Section 75W Modification Application Modification No. 2 to MP10_0075

North Penrith Development

Coreen Avenue, Penrith

Submitted to Department of Planning and Infrastructure
On Behalf of Landcom

Figure 5 – Revised staging plan

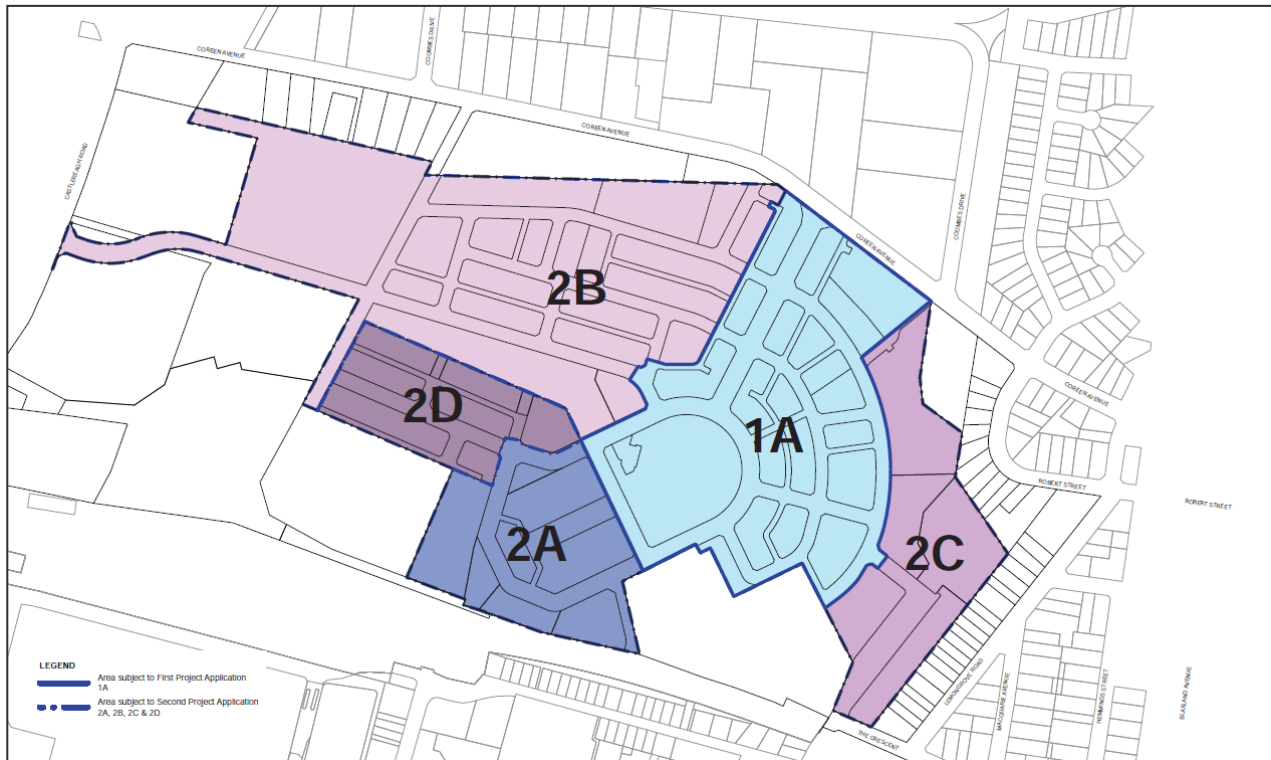
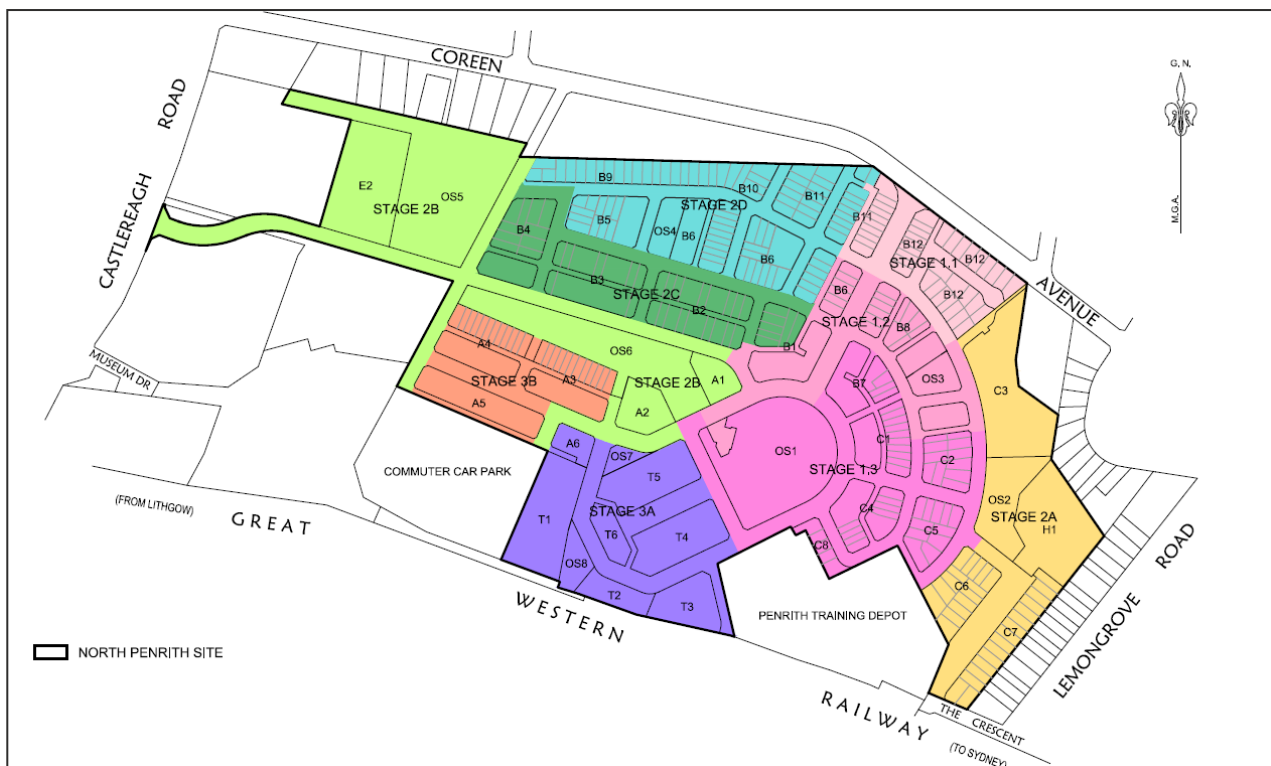
As outlined earlier in this report, the approved Indicative Staging Plan (Figure 44 of the approved Concept Plan EAR and reproduced below in **Figure 4**) is proposed to be modified. The approved North Penrith Concept Plan indicates Landcom previously intended to seek approval for the remaining development at North Penrith through a single application and subsequently stage the construction works over 4 sub stages (i.e.: Stages 2A-2D).

The State Government's 10,000 Lot Program prompted Landcom to review the North Penrith development strategy. A revised staging plan for the development is provided at **Figure 5**, which provides Landcom with more flexibility in the roll out of the development, appointment of contracts and also provide better alignment of development consents and associated utility approvals. The revised staging better facilitates the expeditious delivery of residential lots to the market by isolating particular site constraints, whilst minimising development assessment being held up by issues that are not relevant to individual sub stages.
